RECORD OF DECISION AMENDMENT

ANACONDA REGIONAL WATER, WASTE, AND SOILS OPERABLE UNIT

Anaconda Smelter National Priorities List Site
Anaconda – Deer Lodge County, Montana

September 2011

Figure 4-1. Opportunity Ponds Subarea Significant Changes
Anaconda Regional Water, Waste, & Soils OU
Anaconda Smelter NPL Site, Montana

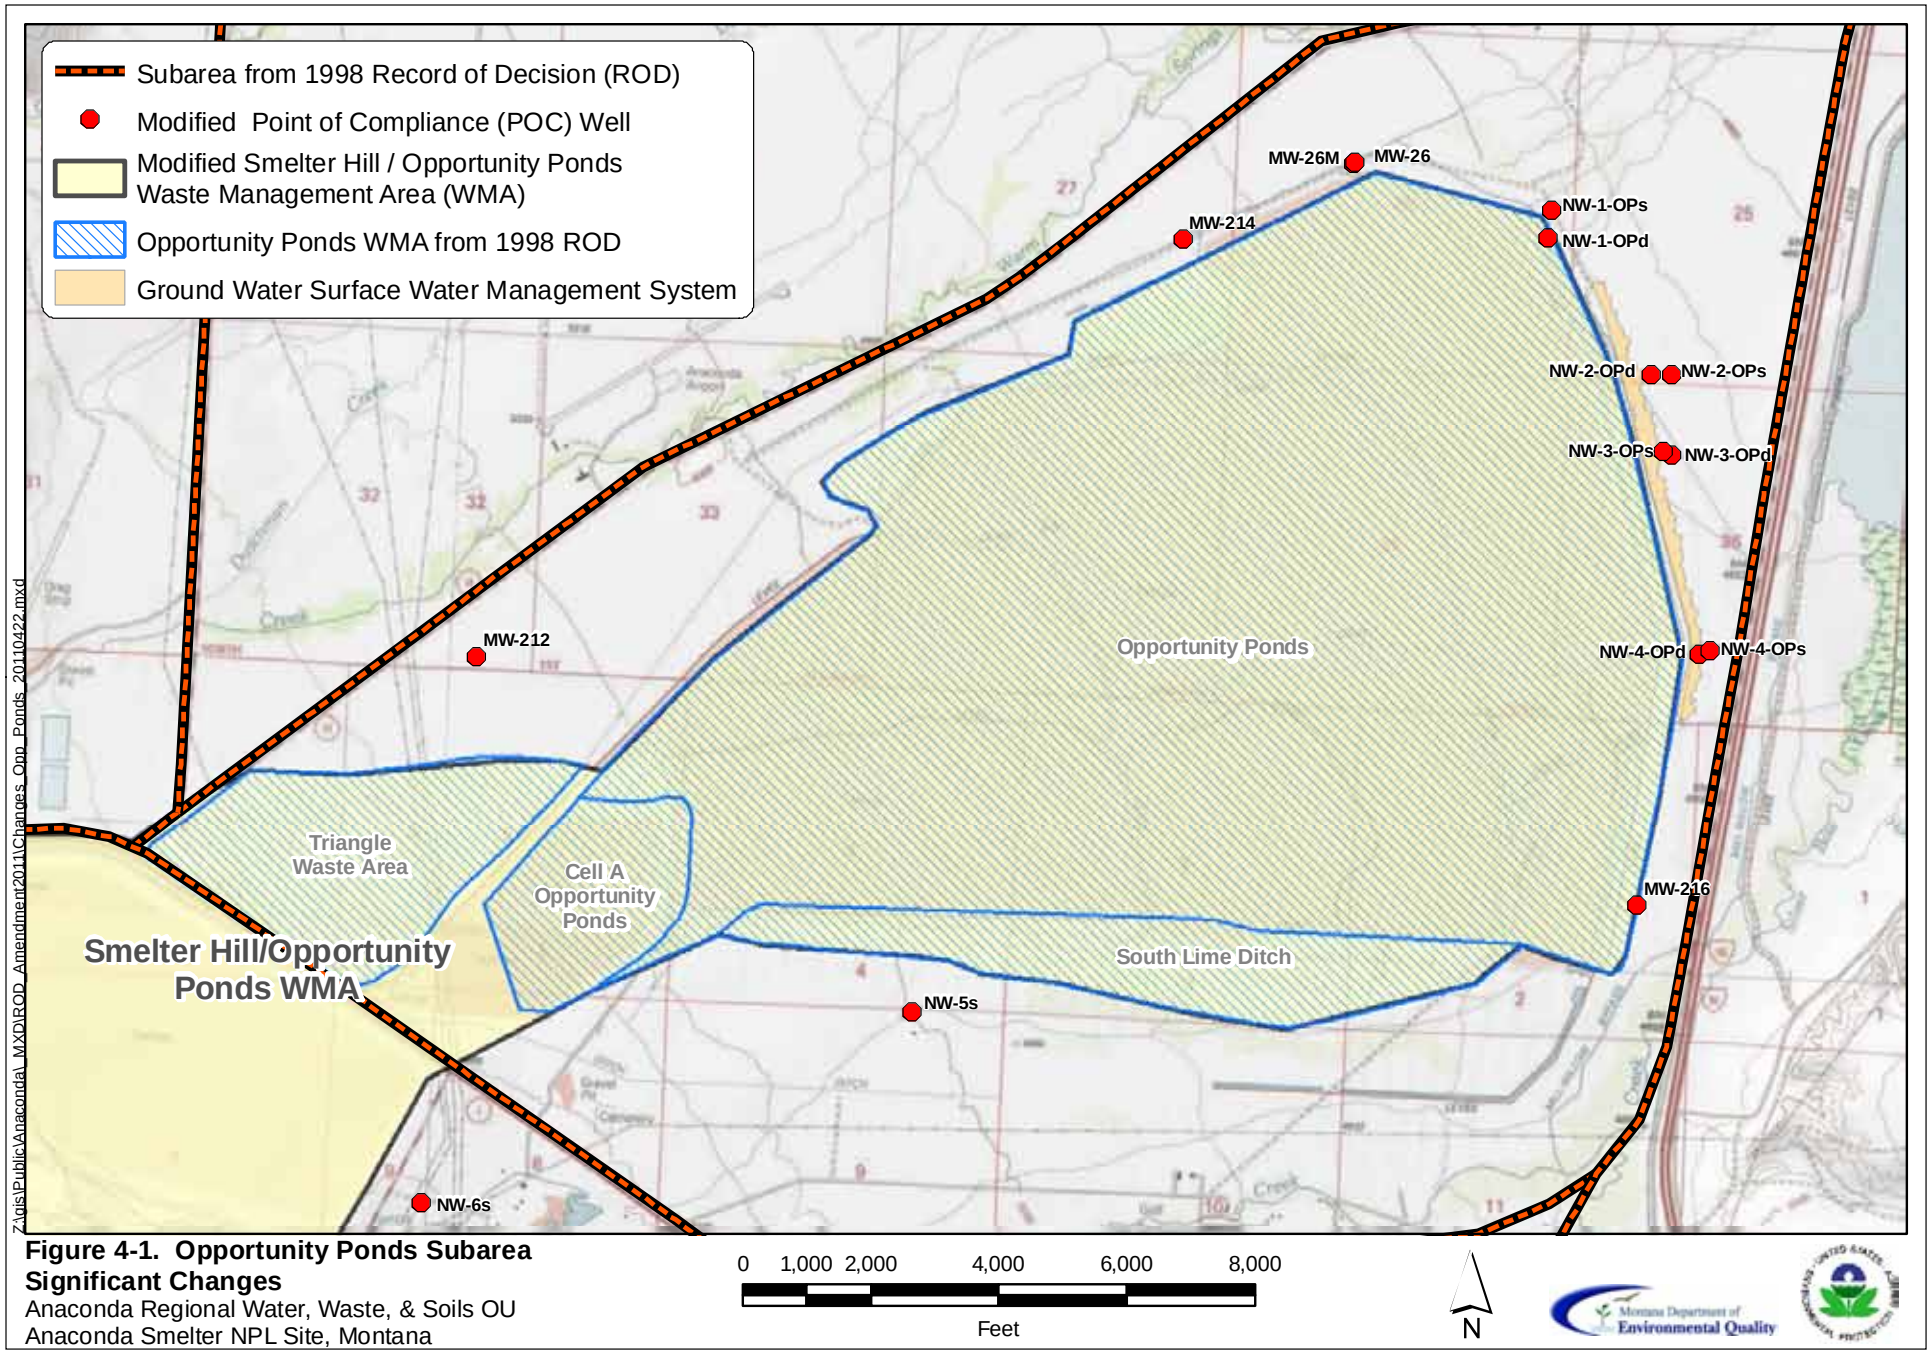
This ROD Amendment incorporates the Triangle Waste Area into the Opportunity Ponds WMA. Inclusion of the Triangle Waste Area into the Opportunity Ponds WMA leads to a merger of the Smelter Hill and Opportunity Ponds WMAs into one WMA, the Smelter Hill/Opportunity Ponds WMA. Figure 4-1 shows the revised Opportunity Ponds WMA boundary compared to the 1998 boundary, and new ground water POC.

With the merging of the Smelter Hill and Opportunity Ponds WMAs, several POC wells have been removed from the toe of the Anaconda Ponds. Due to the potential for contaminant plume migration cross-gradient from the ponds, several new POC well locations are also added north and south of the combined Smelter Hill/Opportunity Ponds WMA. This was a community concern.

Remedial requirements for ground water containment at the Smelter Hill/Opportunity Ponds WMA identified in the 1998 ROD are unchanged. The Smelter Hill/Opportunity Ponds ground water POCs are shown on Figure 4-1.

1. The Opportunity Ponds WMA has been expanded, as shown in Figure 4-1.
2. The Smelter Hill WMA has been expanded, as shown in Figure 8-1.
3. The Opportunity Ponds and Smelter Hill WMAs have been merged into a single WMA, as shown in Figure 3-3.
4. The Old Works WMA has been expanded, as shown in Figure 7-1.
5. The Uplands Soils Areas of Concern has been expanded, as shown in Figure 3-4.
6. A Dutchman HAA has been designated, as shown in Figure 5-1
7. A Smelter Hill HAA has been designated, as shown in Figure 8-1.
8. Additional abandoned railroad wastes have been identified for disposal into a WMA, as described in Section 8.3.

9. New POC locations have been established for the Smelter Hill/Opportunity Ponds WMA, as shown in Figure 4-1.
10. A GWSWMS has been constructed along a portion of the toe of the Opportunity Ponds tailings impoundment to address potential arsenic ground water plume movement.
11. New POC locations have been established for the Old Works WMA, as shown in Figure 7-1.
12. The arsenic human health standard for ground water has been waived for the North Opportunity Alluvial Aquifer TI Zone, as shown in Figure 5-1.

Figure 5-1. North Opportunity Subarea Fundamental and Significant Changes
Anaconda Regional Water, Waste, & Soils OU
Anaconda Smelter NPL Site, Montana

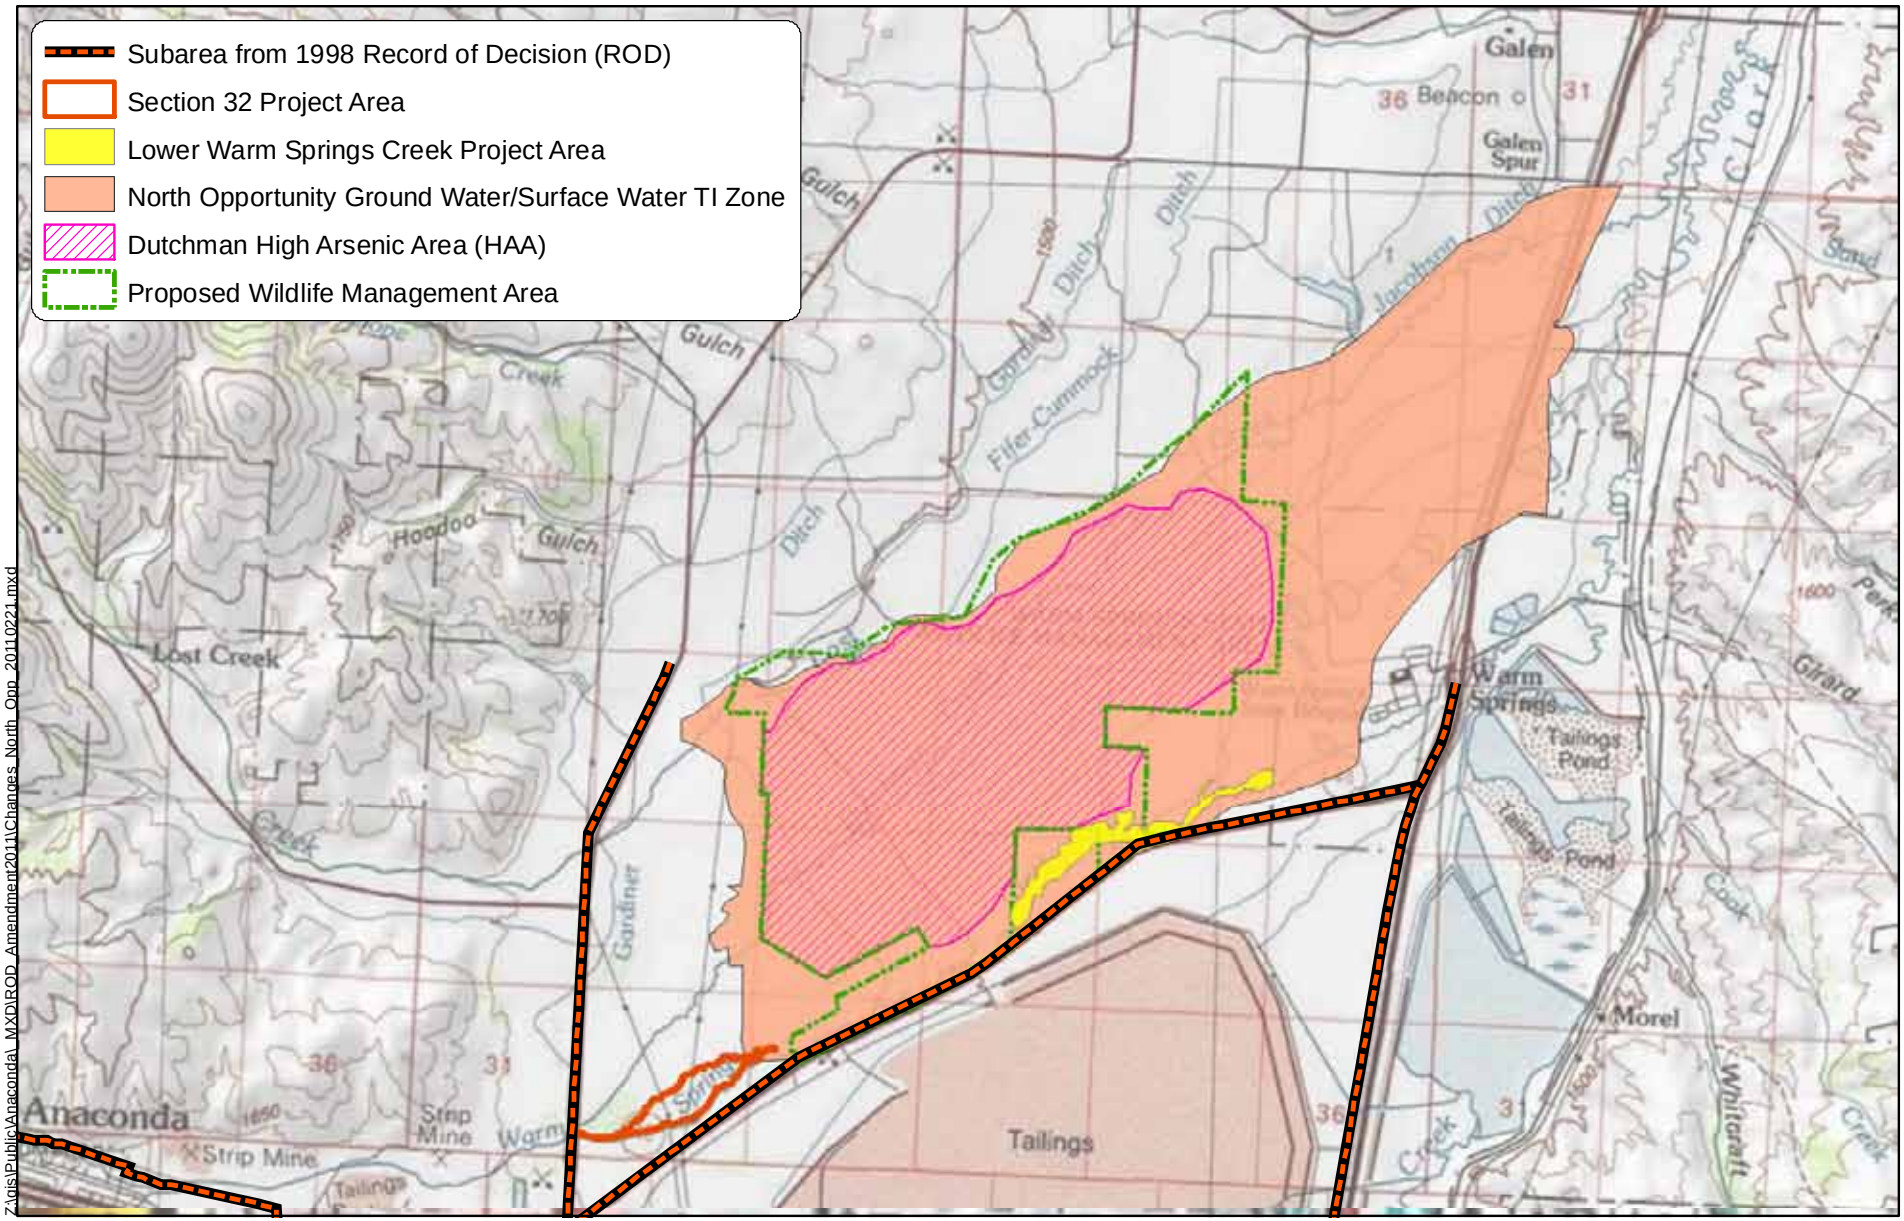
This ROD Amendment designates the Dutchman HAA as shown in Figure 5-1. This area is generally located by an area bounded by Lost Creek to the north, near the community of Warm Springs to the east, Warm Springs Creek to the south, and the ADLC airport to the west. Land use in this area includes agriculture, grazing, open space wildlife habitat, and recreational uses such as bird watching and hunting. Three streams traverse the area from southwest to northeast (Lost Creek, Dutchman Creek, and Warm Springs Creek) along with numerous smaller springs or seeps. The Dutchman HAA is a well vegetated wetland that includes a highly functional ecosystem. There are soils that exceed the ARWW&S OU recreational/open space/agricultural action level of 1000 mg/kg arsenic (RRU 2001, Atlantic Richfield 2004b). Because of the ameliorating effects of shallow ground water and abundant surface water resources, the Dutchman HAA is well-vegetated despite high arsenic concentrations in the shallow soil.

This ROD Amendment includes the two specific Warm Springs Creek areas shown on Figure 5-1. Since the 2005 investigations in the Section 32 area, Atlantic Richfield has completed waste removal in the Warm Springs Creek floodplain under the North Opportunity RA. Approximately 100,000 cy of soil and soil/waste mixed material were removed and transported to the Opportunity Ponds WMA in 2009 and 2010 for disposal. The underlying soil has been treated, amended, seeded, and fertilized. This completed waste removal leaves only minor amounts of waste removal along the stream corridor for the Section 32 reach.

Design elements for Warm Springs Creek Floodplain include the removal of wastes and soils/waste mixtures from the floodplain, transport of these contaminated materials to the Opportunity Ponds WMA for disposal, streambank stabilization, treatment, and backfill, if necessary, of the waste removal areas. An estimated 40,000 cubic yards of soil/waste removal is identified for Lower Warm Springs Creek project area within the area shown in Figure 5-1.

Figure 6-1. South Opportunity Subarea Fundamental Changes
Anaconda Regional Water, Waste, & Soils OU
Anaconda Smelter NPL Site, Montana

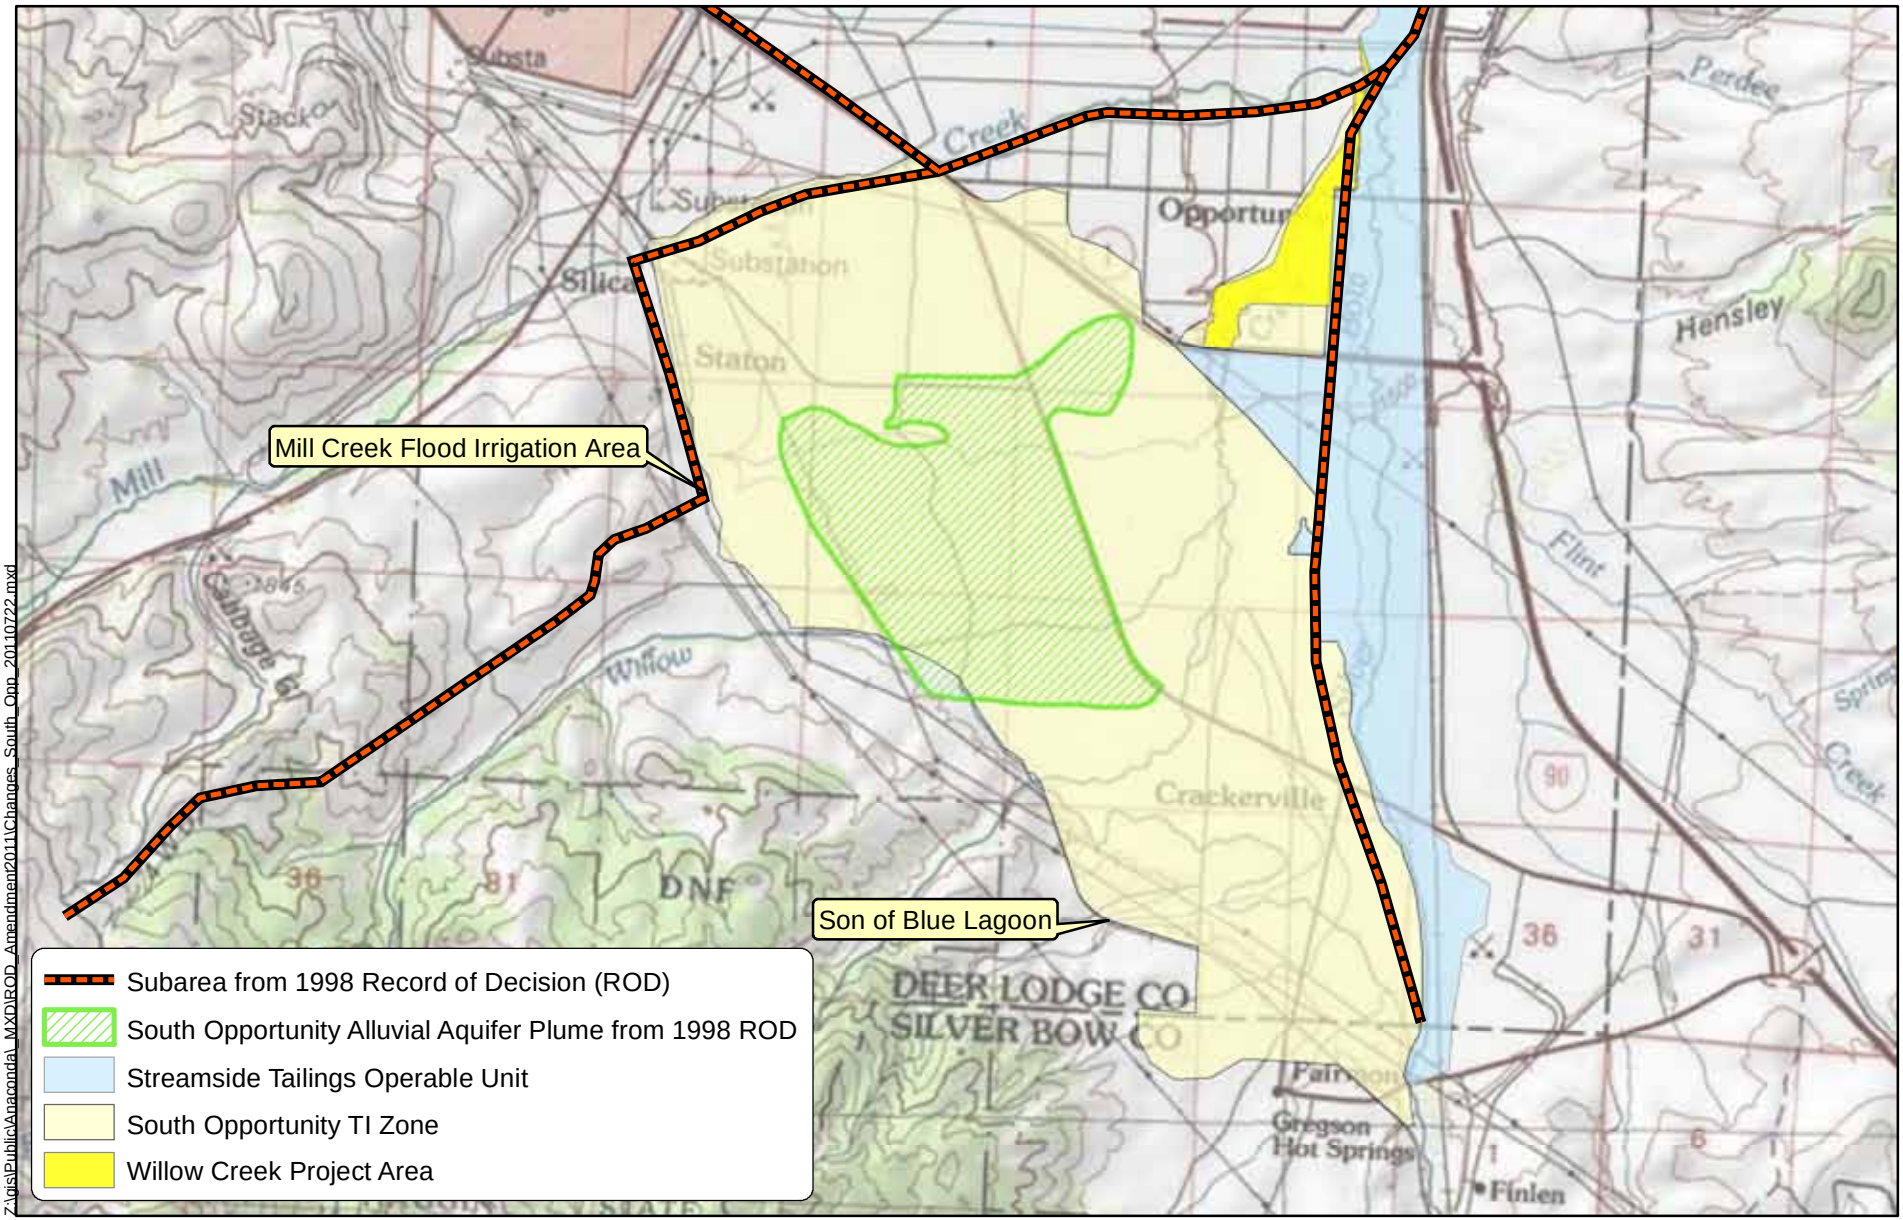
During RD, two other locations (shown on Figure 6-1) where surface water intercepts railroad embankment materials and subsequently results in COCs leaching into surface water were identified and included. These areas, as well as the railroad crossings at Mill and Willow Creeks, will be addressed as part of remedy and are included in the RDU 5 Active Railroad East/Blue Lagoon RA Work Plan/Final Design Report (Atlantic Richfield 2007a). Improvements to minimize surface water contamination at the areas are also required and are identified in this work plan.

The South Opportunity Ground Water/ Surface Water Area of Concern consists of valley bottom land located within an area generally bounded by Mill Creek to the north, the Streamside Tailings OU to the east, the Silver Bow County line to the south, and uplands associated with the Mount Haggin Wildlife Management Area (also the bedrock TI Zone) to the west. Figure 6-1 shows the South Opportunity Ground Water/ Surface Water Area of Concern.

Surface water investigations conducted in 1993 and 2007 attempted to sample all tributaries to lower Willow Creek. All samples exceeded 10 µg/L arsenic confirming the widespread nature of surface water contamination. Figure 6-1 delineates the South Opportunity ground water/surface water TI zone. The area generally includes the valley bottom land located within an area bounded by Mill Creek or Highway 1 to the north, the Streamside Tailings OU to the east, the Silver Bow County line to the south, and uplands associated with the Mount Haggin WMA (also the bedrock TI zone) to the west. Downgradient movement of the plume is hydraulically controlled by discharge into surface water either along Willow Creek or drain tiles. Because of the connection between the extent of wetlands and ground water contamination, wetlands on the north side of Highway 1 are included in the TI zone. Wetlands further north are not included in the TI zone because no data have been collected to indicate that shallow ground water contamination exists in that area. Data from drain tiles and domestic wells indicate very low arsenic concentrations in ground water north of the TI zone.

The revised boundaries of the bedrock TI Zone are shown on Figure 6-1. The bedrock TI zone now includes 63,515 acres or 99 square miles, approximately double the area delineated in the ROD.

13. The arsenic human health standard for ground water has been waived for the South Opportunity Alluvial Aquifer TI Zone, as shown in Figure 6-1.
14. The Bedrock Aquifer TI Zone has been expanded, as shown in Figure 9-1.
15. The remedy for the Blue Lagoon has been changed from drainage control improvements to removal, as discussed in Section 6.2.
16. The remedy for the Yellow Ditch requires significantly more areas of removal than that originally anticipated under the ROD, as discussed in Section 6.3.
17. A Domestic Well Monitoring and Replacement Program is being implemented to ensure that domestic well users do not drink ground water above human health standards, as shown on Figure 9-2 and discussed in Section 9.3.
18. Revised ground water standards to meet current state and federal requirements are adopted, as identified in Table 3-1.
